Addendum No. 01

Project Name: HMK Site Improvement
Project No.: 2024543
Bid Date: April 9, 2026
Owner Name: Grand County School District
505 N Mivida Drive
Moab, Utah 84532
Attn: Matthew Keyes

HMK ELEMENTARY SITE IMPROVEMENTS

A1.1 Sheet AS101 – ADDITION OF CONCRETE CURBS AND CONCRETE PAVING

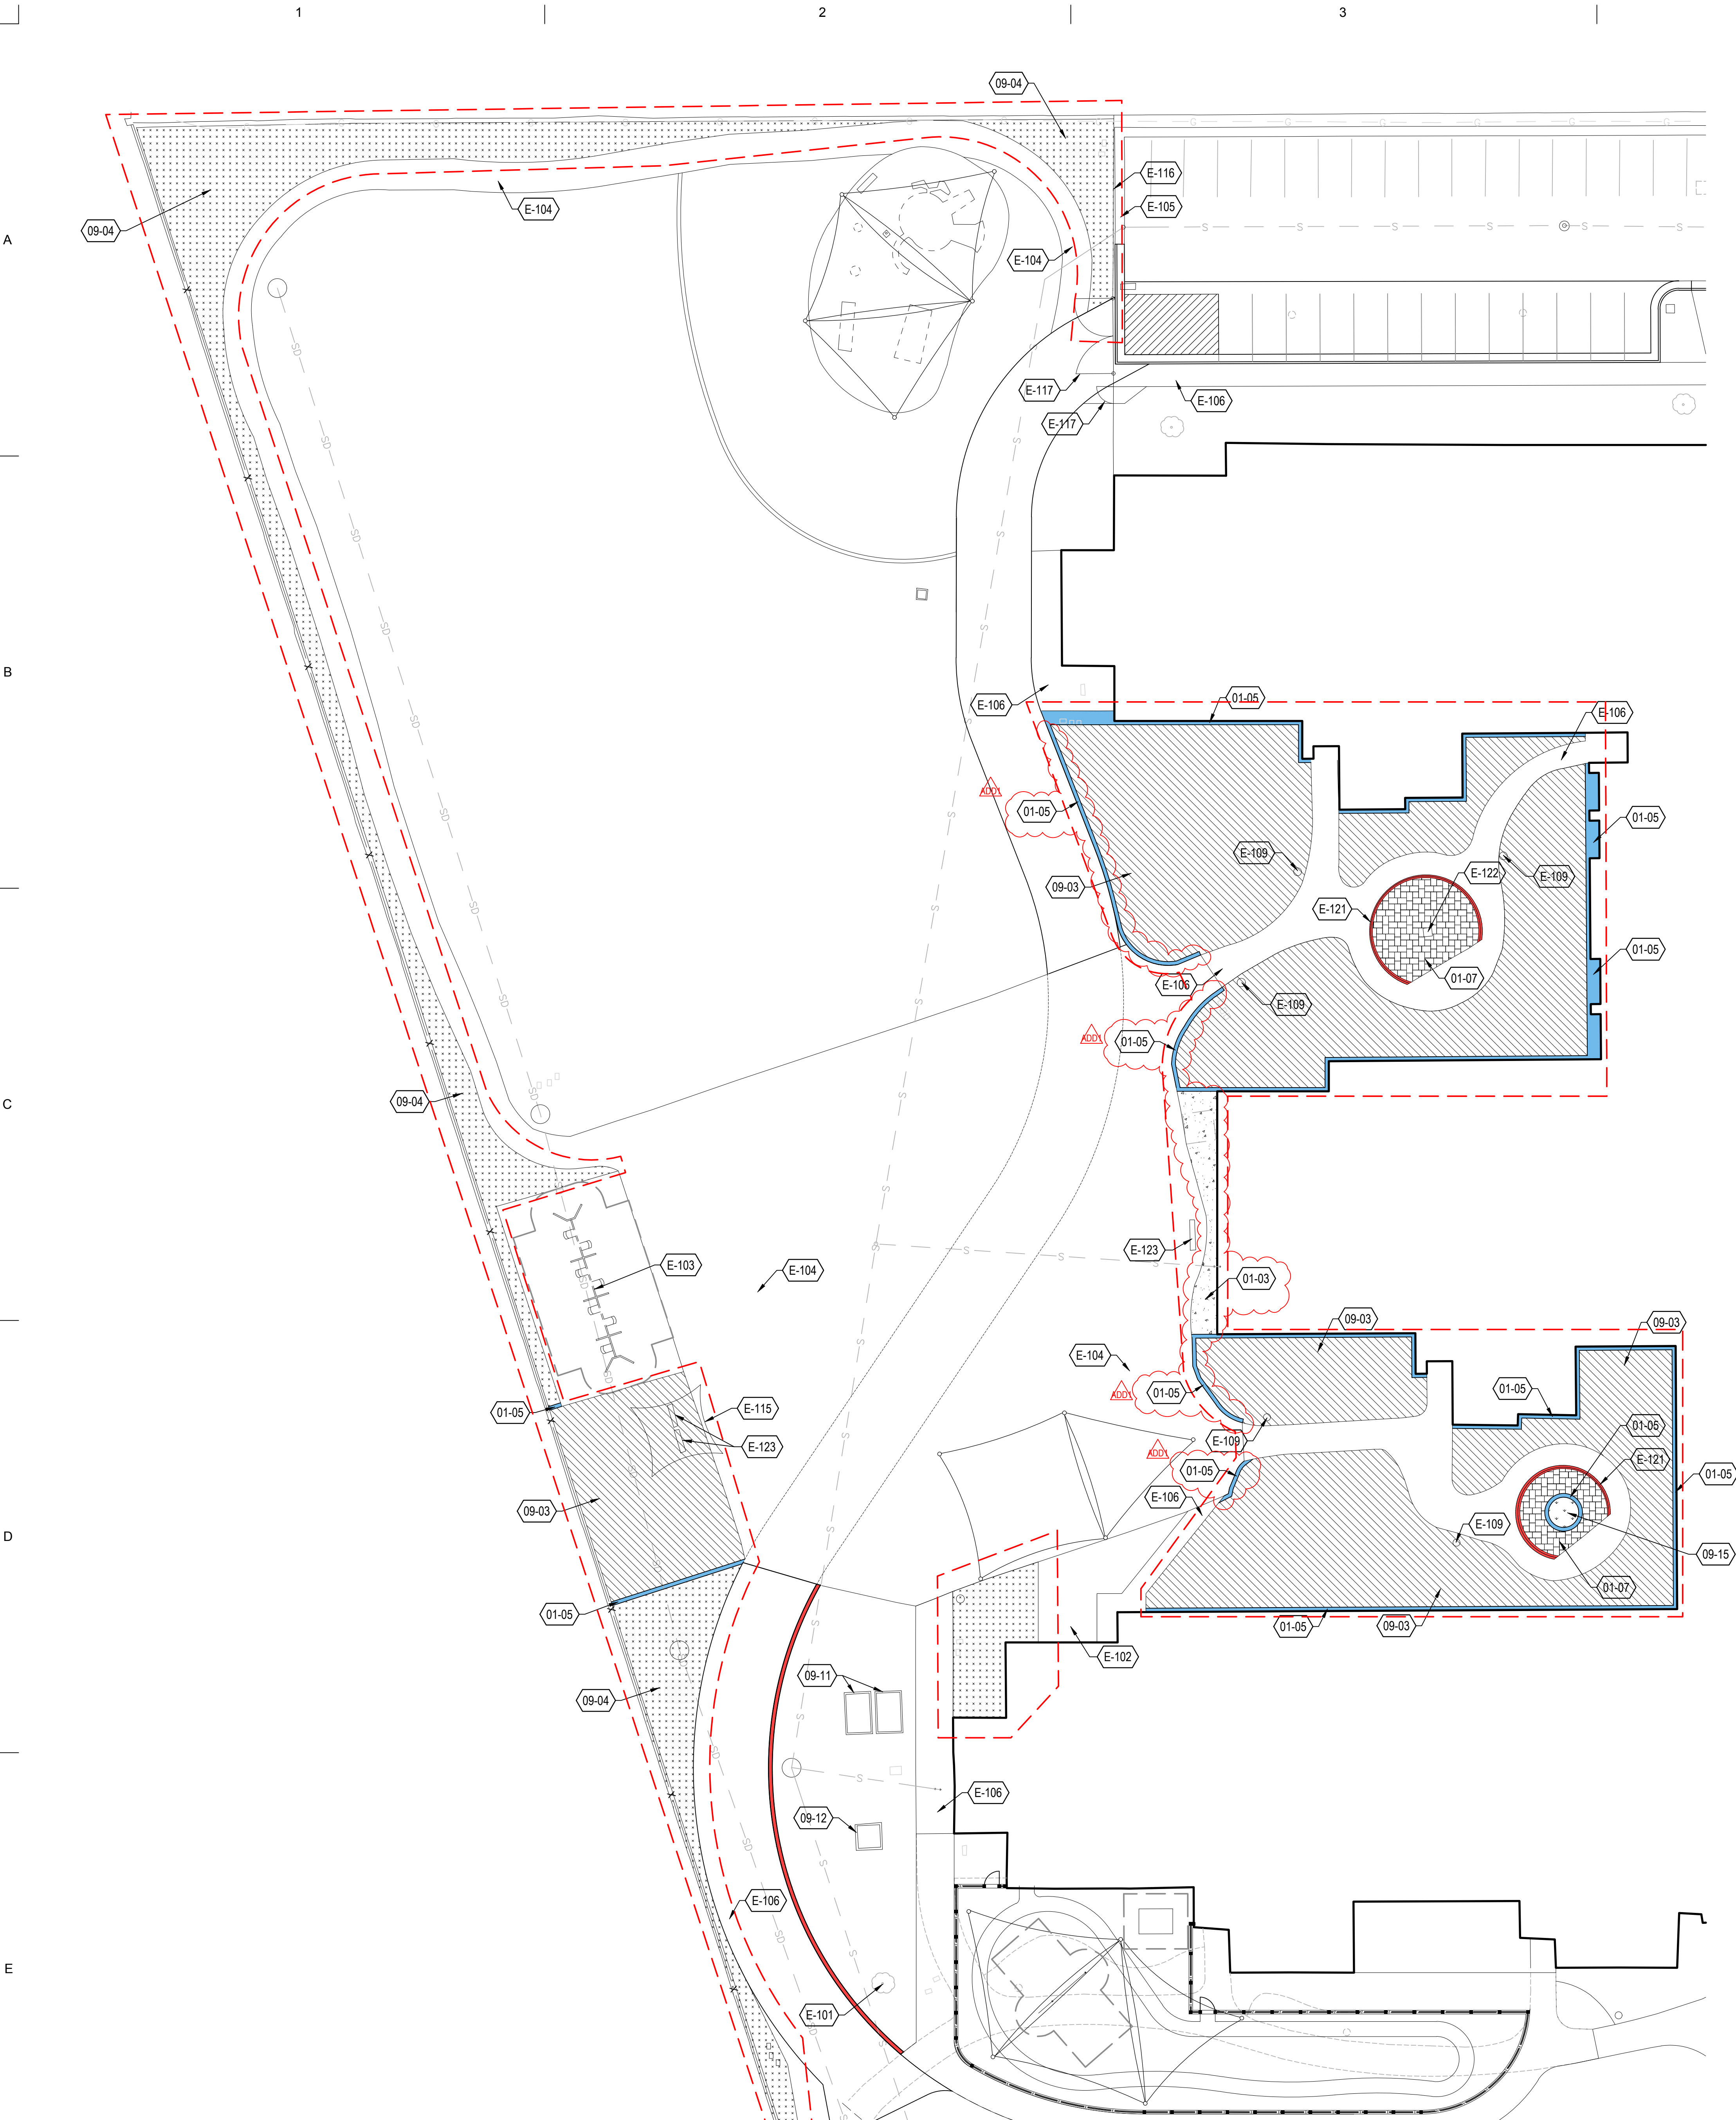
- Added concrete curbs and concrete paving as shown on the attached AS101
